UNITED STATES PATENT AND TRADEMARK OFFICE

APPLICATION NO.	FILING DATE	FIRST NAMED INVENTOR	ATTORNEY DOCKET NO.	CONFIRMATION NO.
10/825,907	04/15/2004	James J. Keenan	381-27-065	8929
23935	7590	05/03/2006	EXAMINER	
KOPPEL, PATRICK & HEYBL 555 ST. CHARLES DRIVE SUITE 107 THOUSAND OAKS, CA 91360			PAPE, ZACHARY	
			ART UNIT	PAPER NUMBER
			2835

DETAILED ACTION

FIG. 1

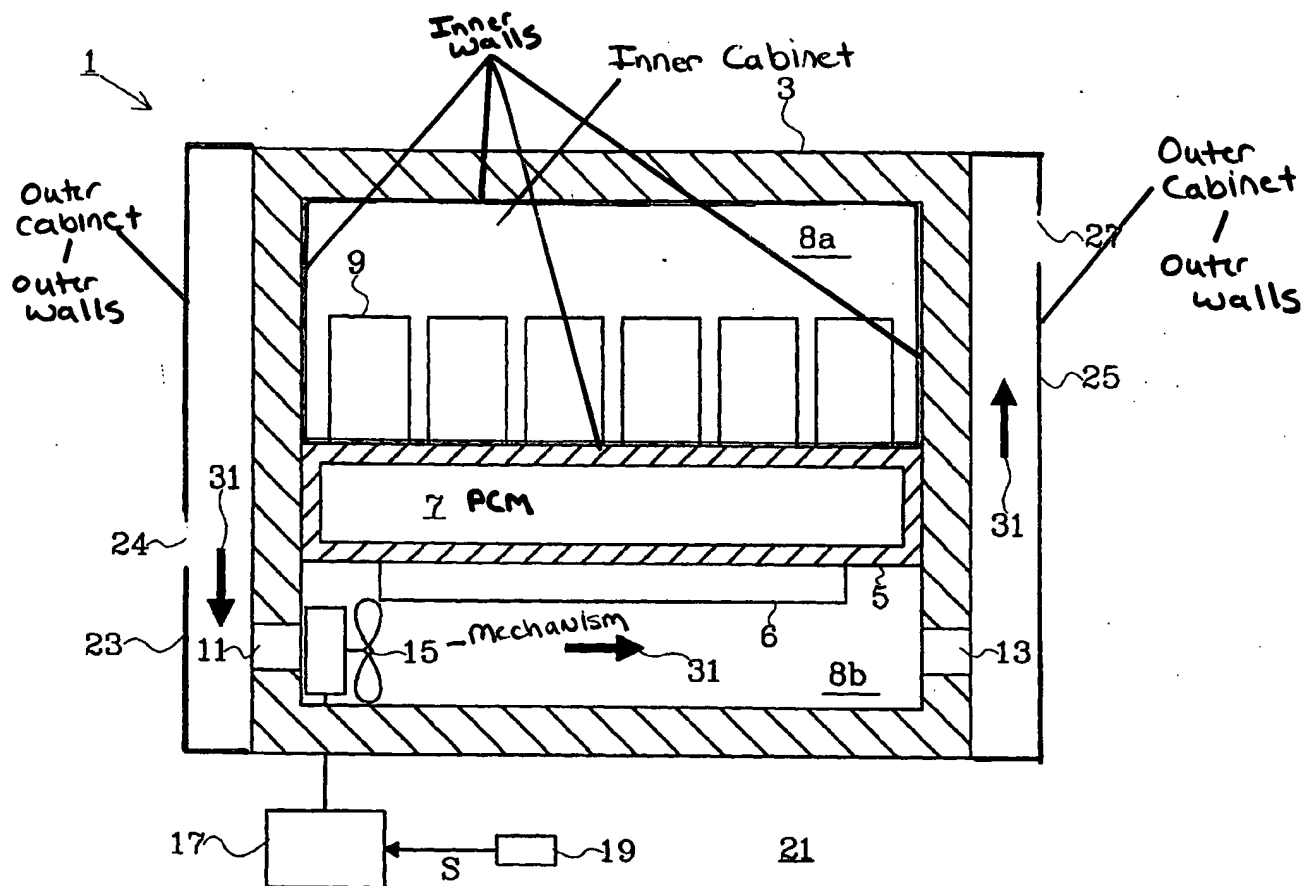
With respect to claim 1, Gudmundsson et al. teaches a cabinet, comprising: an inner cabinet (As illustrated in attached Fig) comprising a plurality of inner walls that form an enclosure (As illustrated in attached Fig); a first phase change material (PCM - 7) disposed outside said enclosure in compartments (35) and covering at least some of said plurality of inner walls (I.E. top of 5, see also Paragraph 23); an outer cabinet (Comprising 23, and 25) positioned around said inner cabinet (As illustrated in Fig 1) and also comprising a plurality of outer walls arranged such that there is a space

(Where arrow 31 is present) between said inner and outer walls; and a mechanism (15) for drawing air from outside of said outer cabinet into the space between said inner and outer walls (As illustrated in Fig 1, air enters at 24, then passes in the void between 23 and 3).

With respect to claim 5, Gudmundsson et al. further teaches that the at least some of said outer walls (Comprising 23, 25) are adjacent to said substantially vertical walls (As illustrated in attached illustration), said mechanism (15) for drawing air arranged to draw outside air between each of said substantially vertical walls and its adjacent one of said outside walls (As illustrated in attached illustration).

With respect to claim 24, Gudmundsson et al. further teaches an electrical enclosure, comprising: a plurality of walls (As illustrated in attached illustration, labeled "inner walls") to establish an electrical component cavity (Comprising 8a); and a phase-change material (7) substantially covering at least one of said plurality of walls (Wherein one of the walls is the top wall of 5 and the phase change material 7 substantially covers the wall); wherein said phase change material insulates said electrical component cavity from heat energy (The phase change material will absorb at least

With respect to claim 30, Gudmundsson et al. further teaches an electrical enclosure, comprising: a plurality of walls (As illustrated in Fig 1) establishing an electrical component cavity (Comprising 8a); a phase-change material (7) and means (5) for containing said phase-change material, said means for containing disposed on one of said plurality of walls (5 is disposed on both the left wall (The wall in which 11 is disposed) and the right wall (The wall in which 13 is disposed)) to establish insulation against heat energy (The phase change material within the means will absorb heat energy and thus establish insulation against heat energy); wherein said phase-change material provides insulation for said electrical enclosure.

With respect to claim 34, Gudmundsson et al. further teaches an exterior wall (Wall in which the controller (17) is attached, as illustrated in Fig 1) spaced apart from at least one of said plurality of phase-change material containers (Since 5.1 of Fig 2 can be placed in 5 of Fig 1 above, the phase change material containers (35) are spaced apart from the exterior wall) to establish an air space (8b).

With respect to claim 39, Gudmundsson et al. further teaches an electrical enclosure, comprising: a phase-change panel (5); an exterior panel (The bottom most panel in which 17 is attached as illustrated in Fig 1) spaced adjacent to said phase change panel; and a fan (15) to circulate air between said phase change panel and exterior panel; wherein said fan reduces thermal energy introduced to said phase-change panel by said exterior wall (Since the fan will carry away heat the exterior panel, it will reduce thermal energy introduced to the phase change panel by the exterior wall).

With respect to the applicants' remarks to claims 24-29 that, "the phase change material would have to be on the inside of any cavities taught by Gudmundsson", the examiner respectfully disagrees. As detailed in the attached illustration, the examiner has defined the cavity to be the space (8a) which is surrounded by the inner walls (Of which the top wall of 5 which the batteries appear to rest on are included). Since the PCM is located below the top wall of 5, it is disposed outside of the component cavity.

With respect to the applicants' remarks to claim 39-41 that, "Gudmundsson does not teach all the limitations of Applicants' claim 39" since, "the fan disposed beneath the contain 5 designed to carry heat generated inside the container to the outside atmosphere through outlet 13", the examiner respectfully notes that claim 39 merely requires that the fan, "reduces thermal energy introduced to said phase-change panel by said exterior wall". The examiner further notes that the fan (15) of Gudmundsson will carry away heat from the exterior panel (Bottom panel which is just below 15) and thus reduce thermal energy introduced to the phase change panel (15) by the exterior wall.

FIG. 2

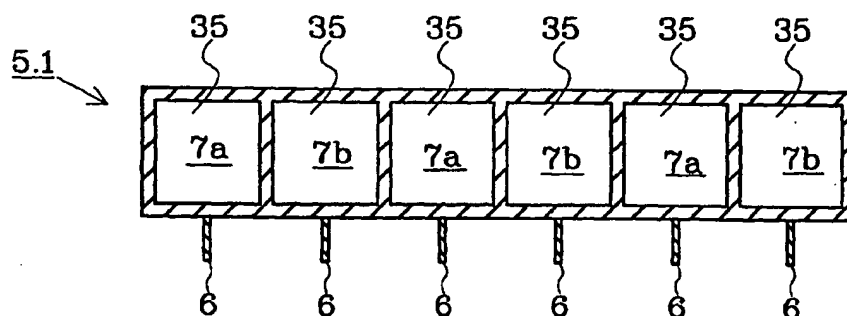
With respect to claim 41, Gudmundsson et al. further teaches that the phase-change panel comprises: spacers (Fig 2 illustrates spacers dividing each cavity (35)) to maintain a cavity for a phase-change material disposed in said phase-change panel.
